doc.: IEEE 802.11-98/168

Critics of IEEE P802.11 response to FCC NPRM 99-149

IEEE802.11 response to NPRM 99-149

WBFH interference to DS

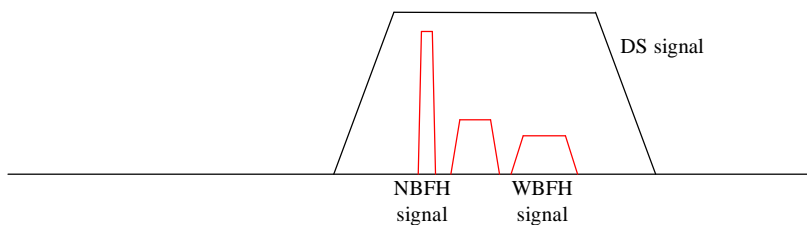
- The SINR depends (almost) only on FH signal power, not its bandwidth.
- The DS-FH collision probability depends on DS BW and width of the hopping band, not on FH BW.

DS interference to NB and WB FH

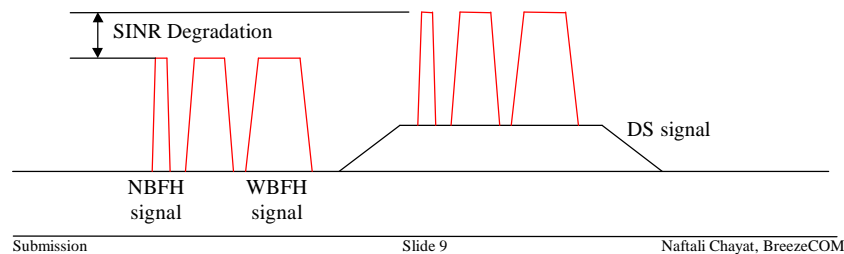
- WBFH needs more received power than NBFH, however SINR degradation due to DS jammer is same!
- The DS-FH collision probability depends on DS BW and width of the hopping band, not on FH BW.

Interference of WBFH to NBFH

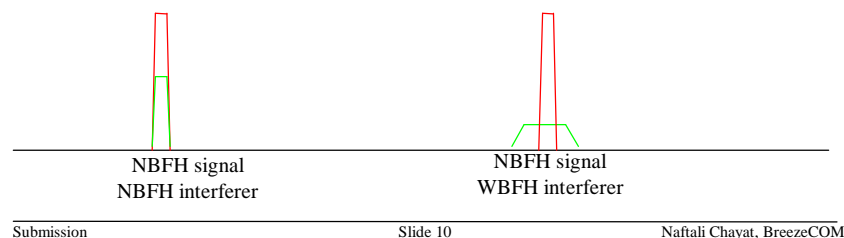
- WBFH interferer needs more received power than NBFH, to fail a desired NBFH signal.
- The collision probability for WBFH is higher, but the percentage of stations within range is smaller

WBFH interference to itself - overlapping or disjoint channels?

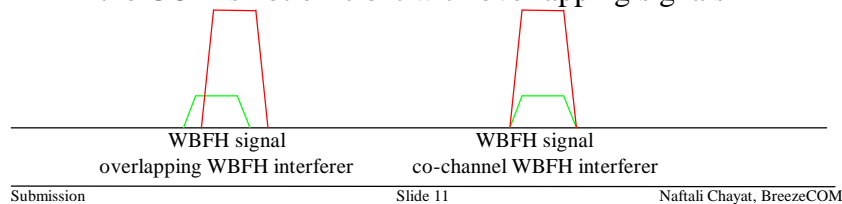
- Overlapping WBFH interferer creates slightly less interference
- The collision probability for overlapping WBFH channels is twice as high.
- Cochannel signals can use CCA to yield to others
 - the CCA is not efficient with overlapping signals
